**SUBJECT: 9100 FLORENCE AVENUE NE (B-20)**  
**Bernalillo County Ref : PWDN 20140036**

## County of Bernalillo Case Comments Report

## AMENDED GRADING AND DRAINAGE PLAN

9100 FLORENCE AVENUE N.E.  
AMENDED GRADING AND DRAINAGE PLAN

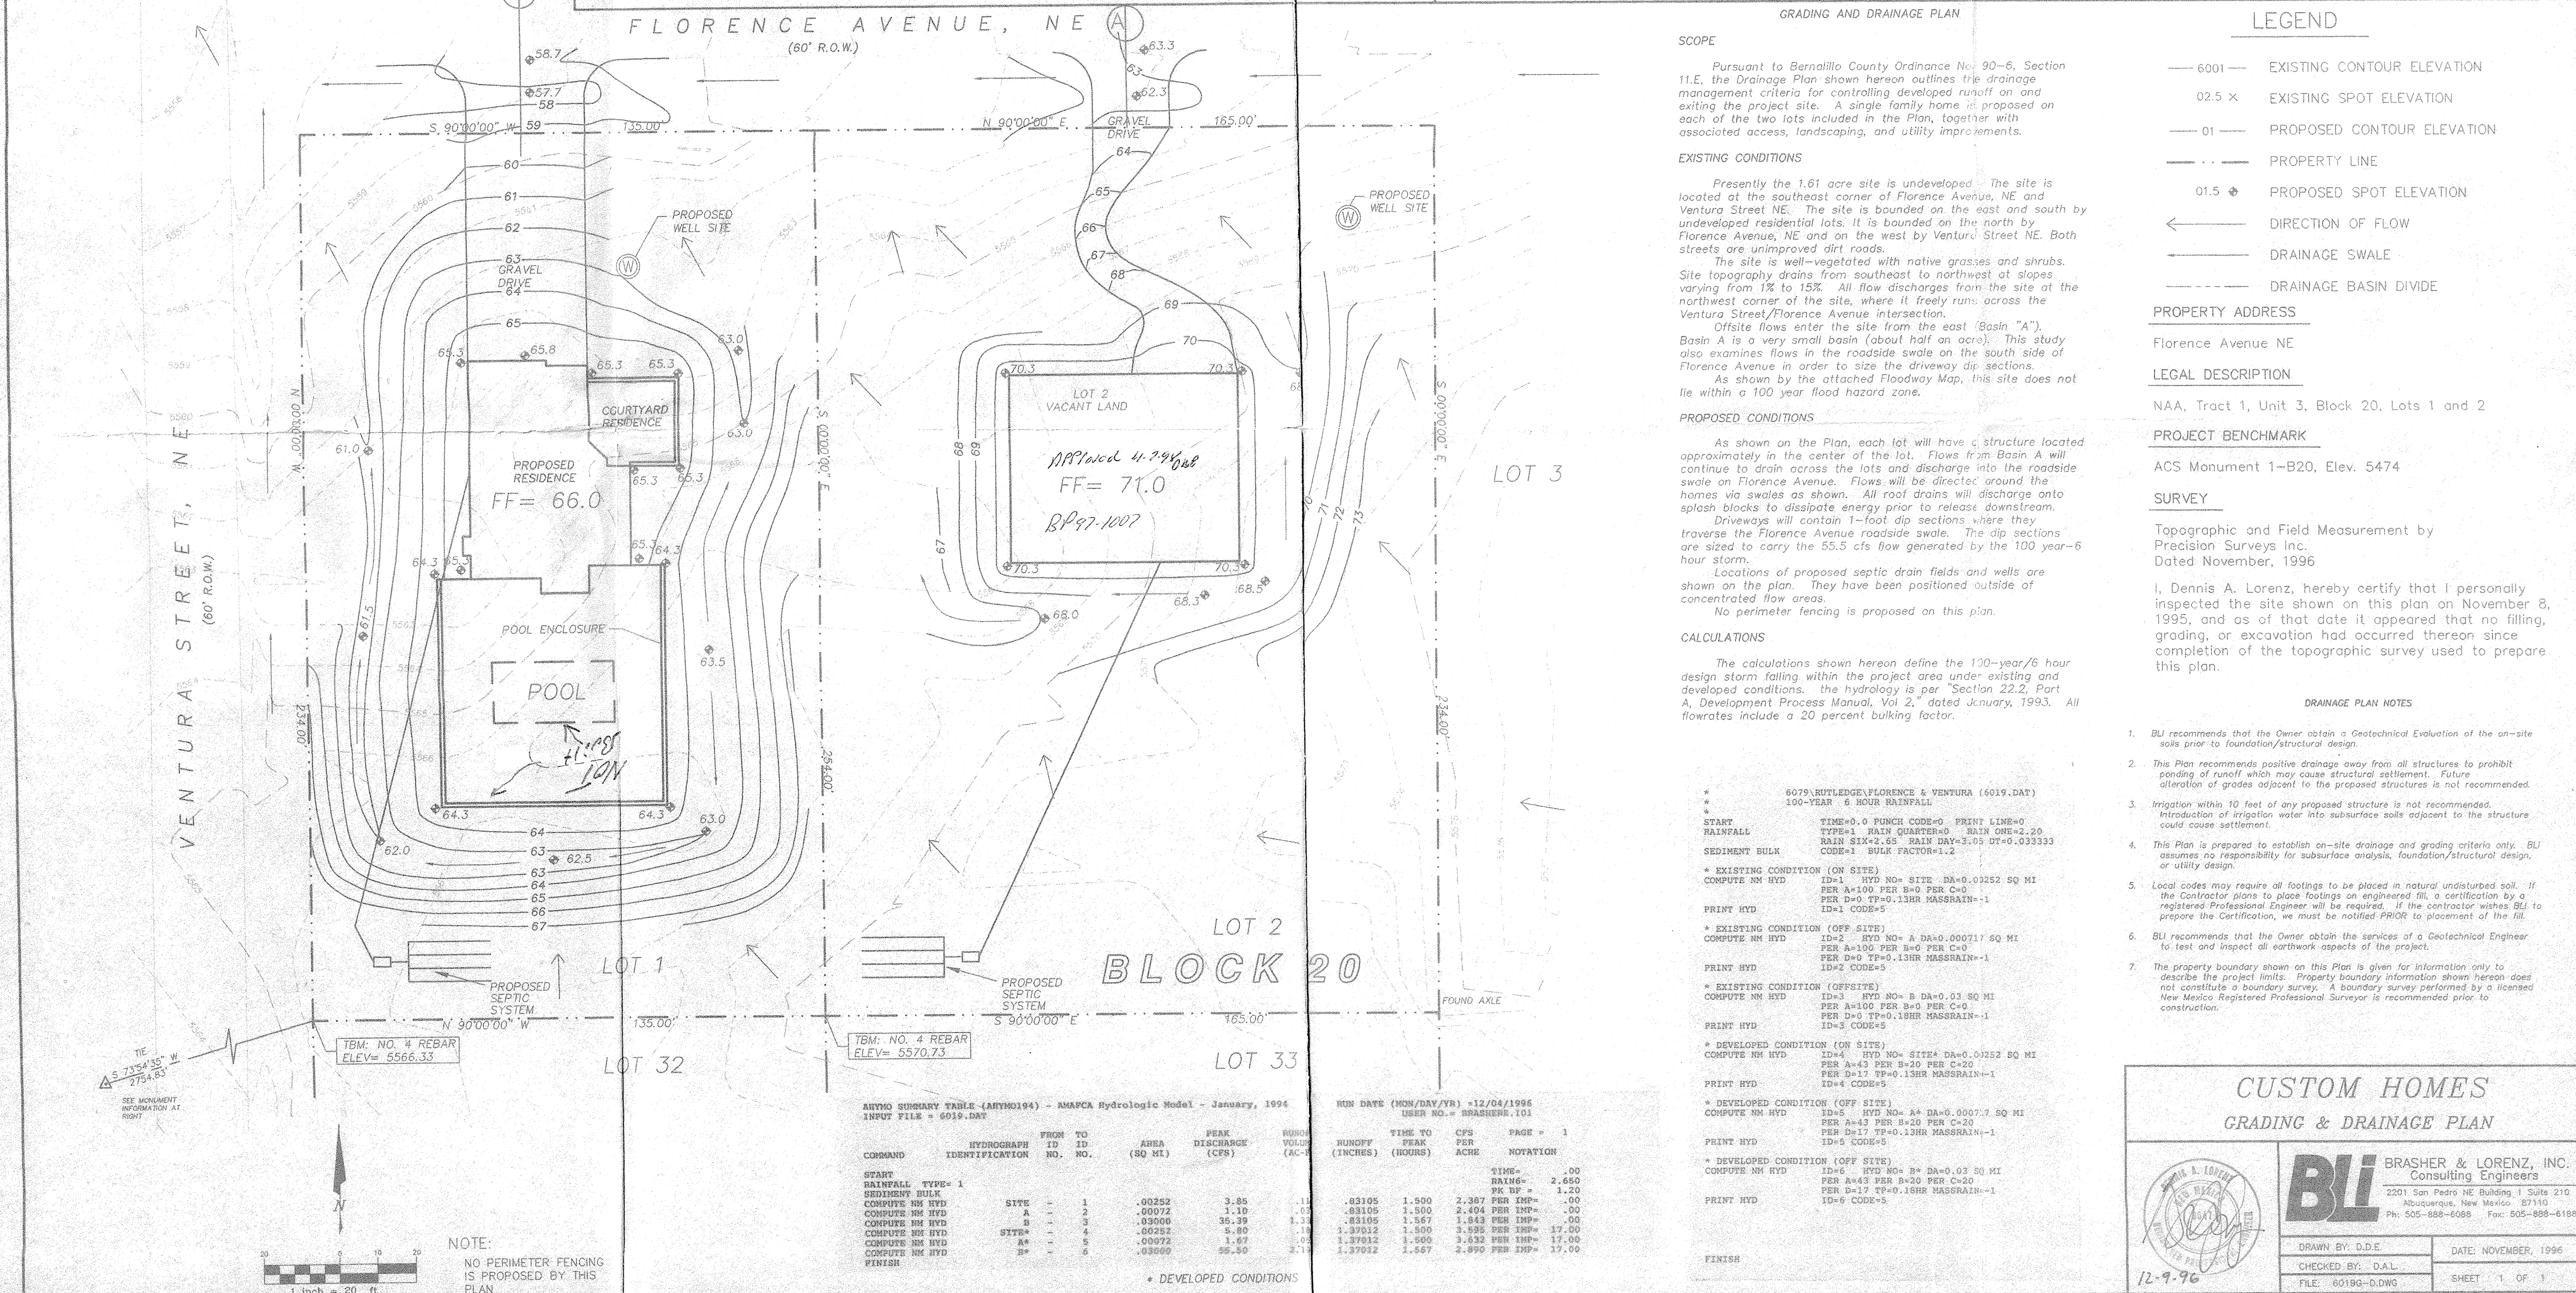
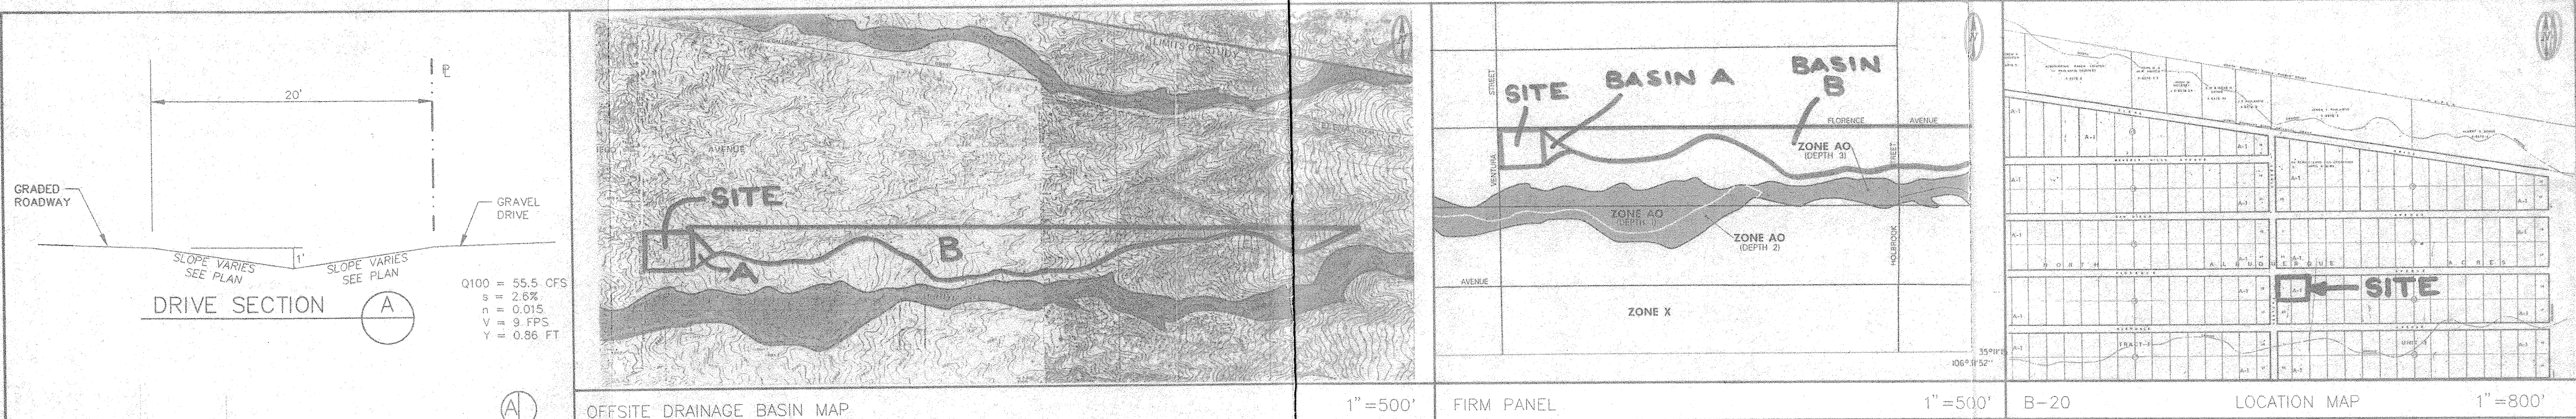
The discharge from the Proposed development is less than the existing conditions discharge. Therefore, the City takes no issue and accepts the proposed discharge from this site.

1) Please revise hydrology calculations based on an allowable 43, 20, 20, 17 land treatment balance for the A, B, C, D land treatments respectively.

2) As a portion of the lot drains to the City of Albuquerque right of way. Please provide a letter from the City indicating acceptance of this discharge.

Attached is the updated Grading and Drainage plan for the subject project. At your request, we have subdivided Basin 'B' in to 2 basins. Basin B-1 drains north to Florence. Basin B-2 drains to the ponding area located in the rear yard. Since Basin B-2 is a closed basin, the proposed peak developed flowrate existing the property into City ROW will be less than the existing condition.

Existing flow into street = 2.43 cfs

Proposed flow into st. fr. BASIN A + B1 = 0.68 + 1.38 = 2.06 cfs

∴ proposed < existing
